ECE/TRANS/WP.29/GRE/2009/47
16 July 2009

Regulations Nos. 19, 48, 98, 112 and 123

Proposal for draft 01 series of amendments to Regulation No. 123
(Adaptive front-lighting systems)

Submitted by the expert from the Working Party "Brussels 1952" */

Figure 1

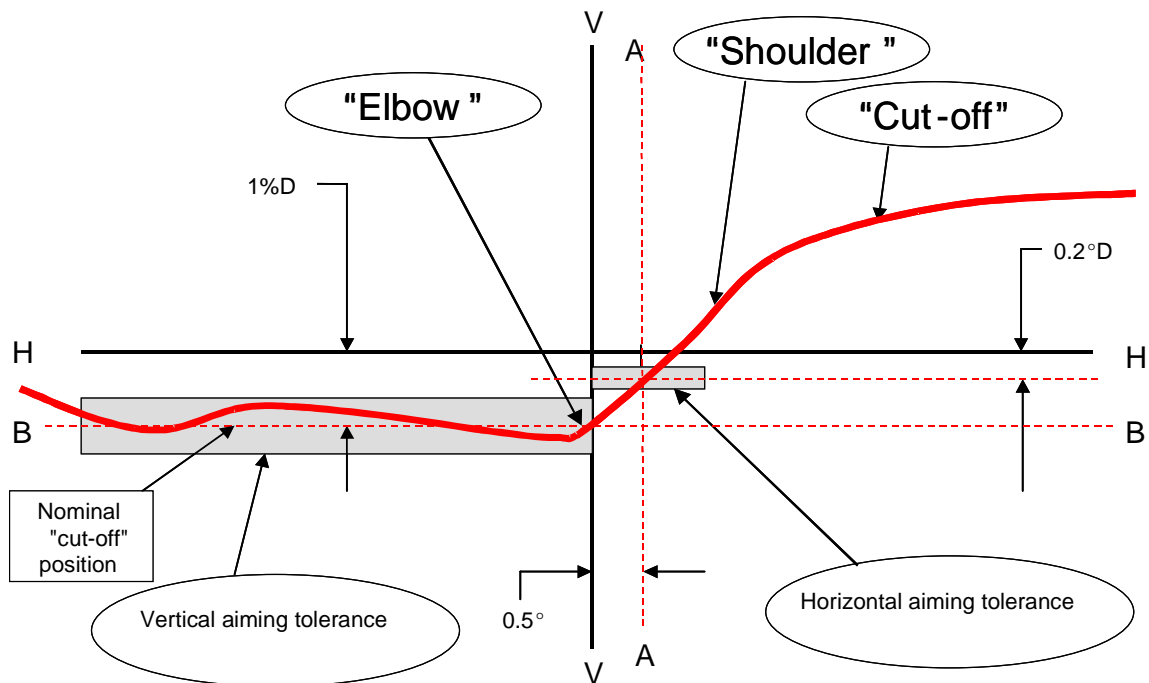
Paragraphs 2.2. and 2.3., amend to read:

"2.2. The beam shall be visually aimed by means of the "cut-off" (see figure 1 below).
The aiming shall be carried out using a flat vertical screen set up at a distance
of 10 m or 25 m (as indicated in section 9 of Annex 1) forward of the headlamp
and at right angles to the H-V axis. The screen shall be sufficiently wide to allow
examination and adjustment of the "cut-off" of the passing beam over at
least 5° on either side of the V-V line.

2.3. for vertical adjustment: the horizontal part of the "cut-off" is moved upward
from below line B and adjusted to its nominal position one per cent (25 cm)
below the H-H line;

Figure 1: Measurement of "cut-off" quality

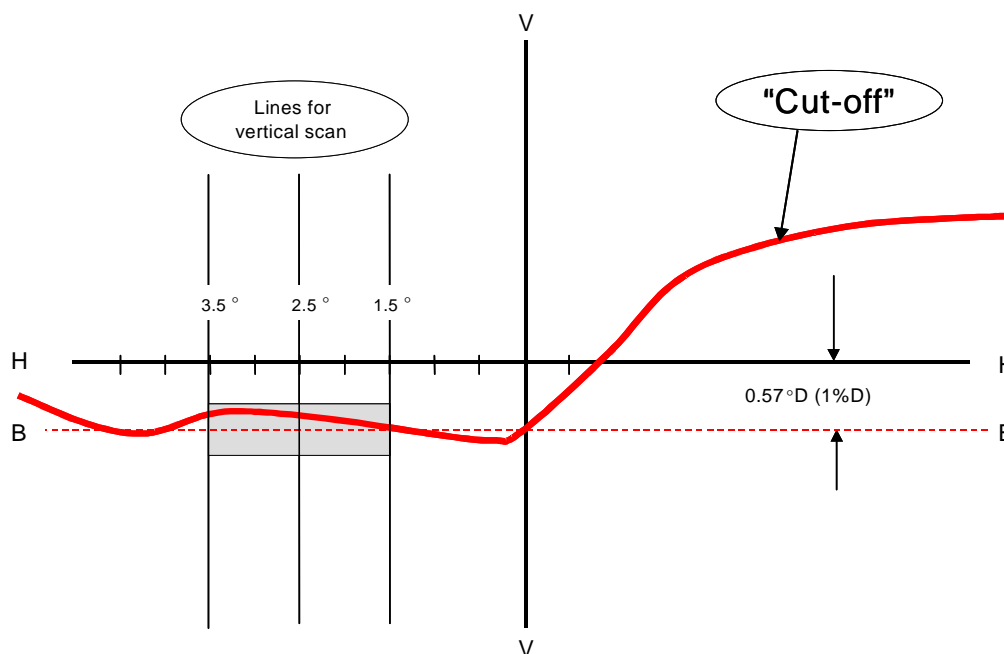
Insert new paragraphs 3 to 3.2., to read:

If the "cut-off" complies with the quality requirements of paragraph 2. of this annex, the beam adjustment may be performed instrumentally.

Figure 2: Instrumental vertical and horizontal adjustment- horizontal line scan method

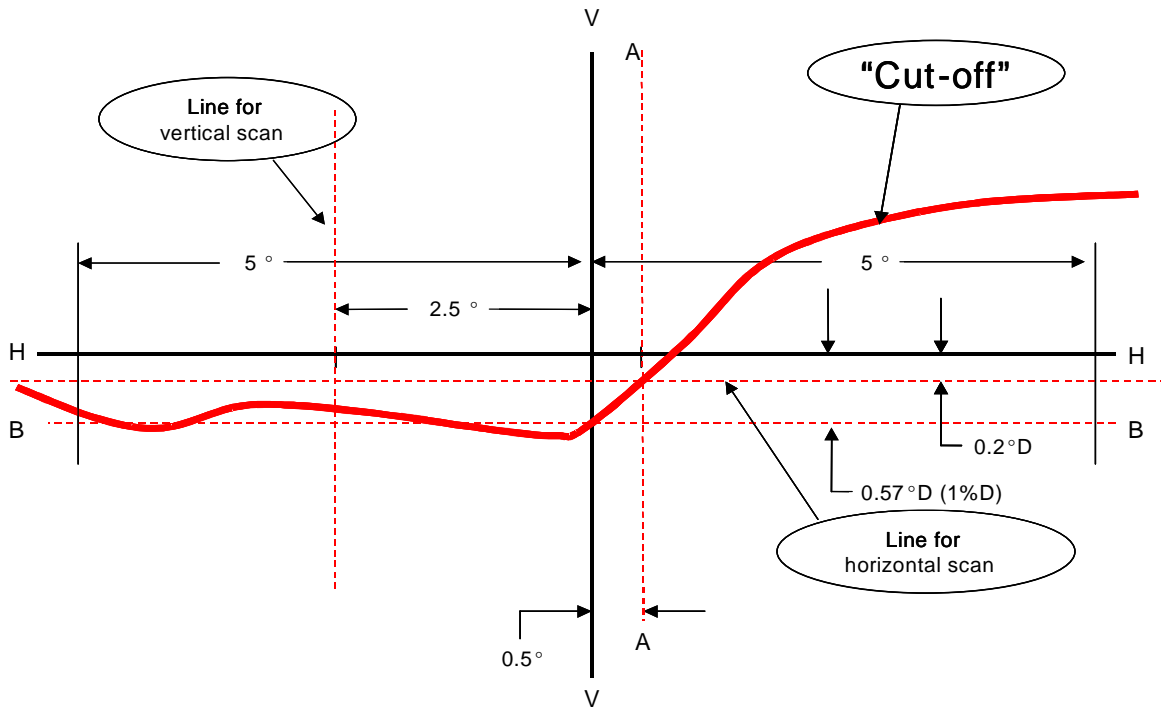
- (a) The "0.2 D line" method (see figure 2 below).

A single horizontal line at 0.2° D shall be scanned from 5° left to 5° right after the lamp has been aimed vertically. The maximum gradient "G" determined

using the formula $G = (\log E_{\beta} - \log E_{(\beta + 0.1^{\circ})})$ where β is the horizontal position in degrees, shall not be less than 0.08.

The inflection point found on the 0.2 D line shall be positioned on the line A.

Figure 3: Instrumental vertical and horizontal adjustment-three line scan method "

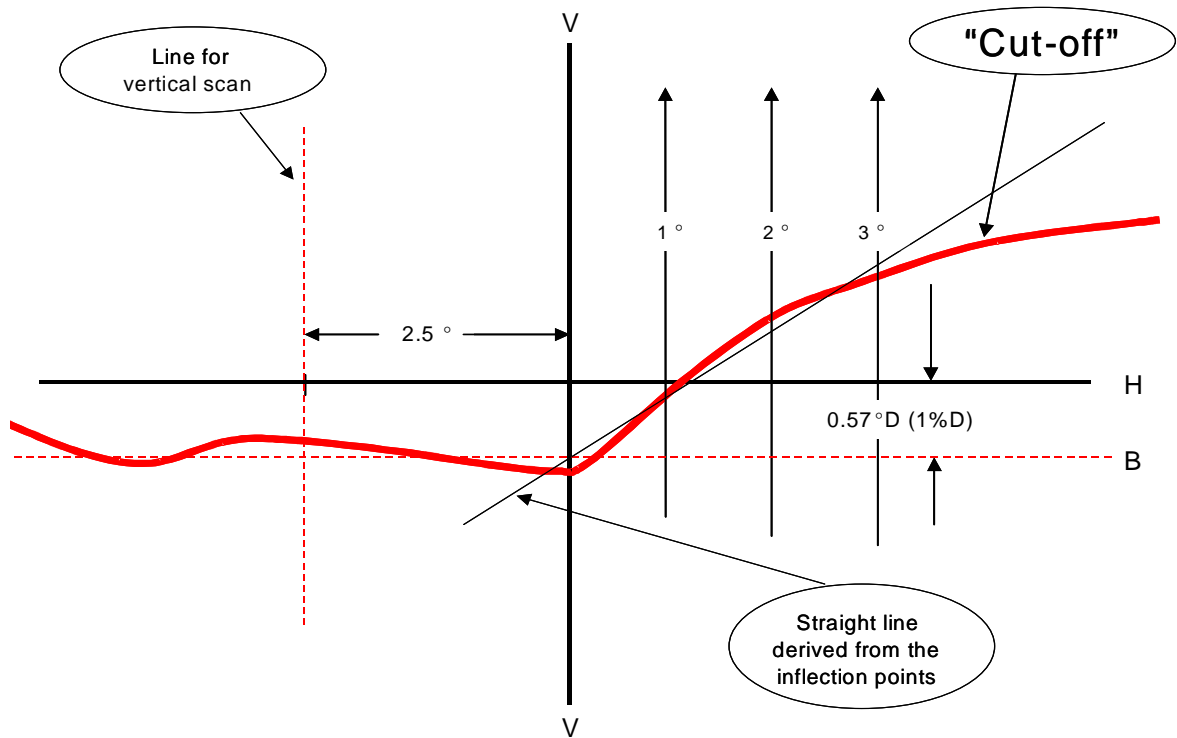
(b) The "3 line" method (see figure 3 below)

Three vertical lines shall be scanned from 2° D to 2° U at 1°R, 2°R, and 3°R after the lamp has been aimed vertically. The respective maximum gradients "G" determined using the formula:

where β is the vertical position in degrees, shall not be less than 0.08. The inflection points found on the three lines shall be used to derive a straight line.

The intersection of this line and the line B found while performing vertical aim shall be placed on the V line.

Diagram 1 "

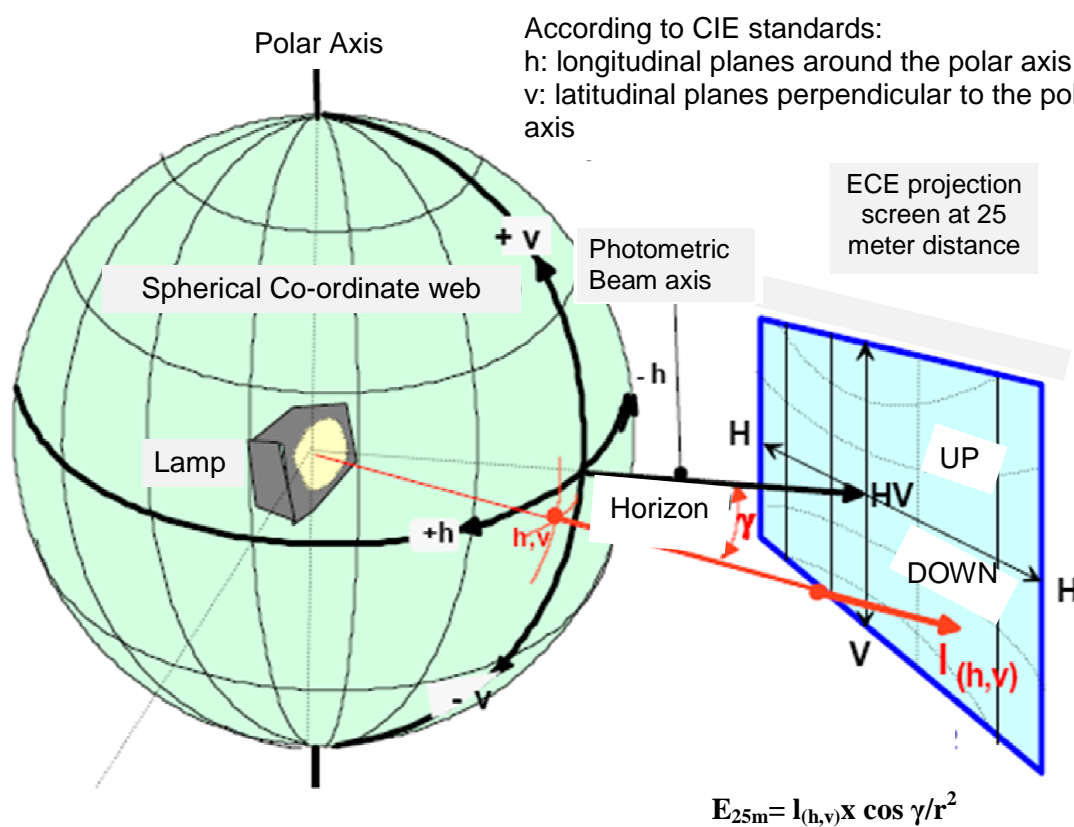
Paragraph 1.5., insert diagram1 and amend to read:

"1.5. The angular co-ordinates are specified in deg on a sphere with a vertical polar axis according to CIE publication No. 70, Vienna 1987, i.e. corresponding to a goniometer with a horizontal ("elevation") axis fixed to the ground and a second, moveable ("rotation") axis perpendicular to the fixed horizontal axis. (See **diagram 1**)"
